Energy Users Association of Australia (EUAA)

ENERGYAUSTRALIA REVISED TRANSMISSION CAPEX PROGRAMME

24 January 2005

Figure 1 EnergyAustralia Capital Expenditure

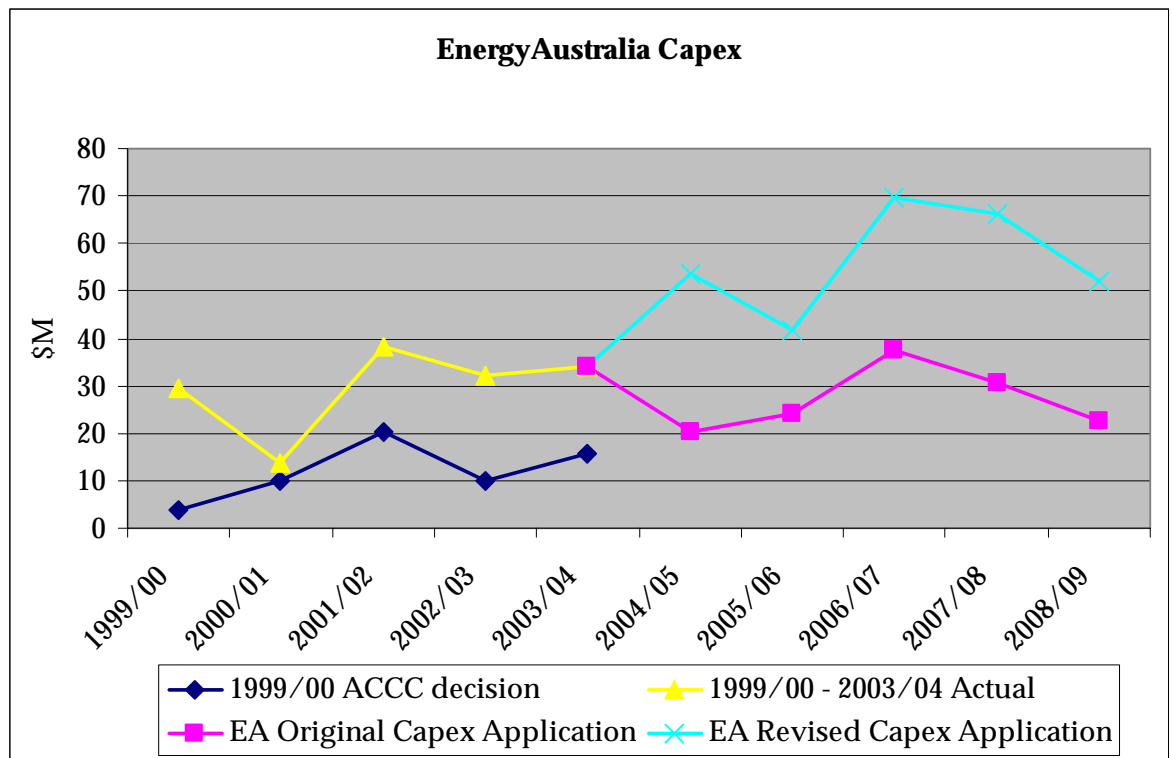
double the \$132m which EnergyAustralia claimed to have spent in the previous period. Surely a capex programme that increases by some 470% over that envisaged just five years ago must be seen to be excessive. The magnitude of the increase (in real terms) can be seen in Figure 1.

Figure 1 shows the history of EnergyAustralia's capex spend. Except for 2000/01 when EnergyAustralia's actual capex spend matched the ACCC's approved capex from the 1999 regulatory decision, EnergyAustralia has consistently overspent on capex. In the first year of the previous regulatory period, EnergyAustralia in fact overspent by about 640%! How could EnergyAustralia be so wrong when it should have had a fairly good understanding of its capex spend just one year ahead? In the final three years, the overspend averaged about 150% pa. What is the value of forecasts when the magnitude of differences between forecast and actuals is so great?

Comparing the current capex forecasts with that provided with the original submission shows that within a six month period, EnergyAustralia has more than doubled their capex forecast. In every year of the forecast period, expected capex spend has increased by between 73% to 165% from that projected just a few months ago prior to the change from ex-post to ex-ante capex approval. This step increase strongly suggests that EnergyAustralia may be engaging in trying to game the ex-ante regime by submitting a high ambit claim to ensure that they will not exceed their capex cap.
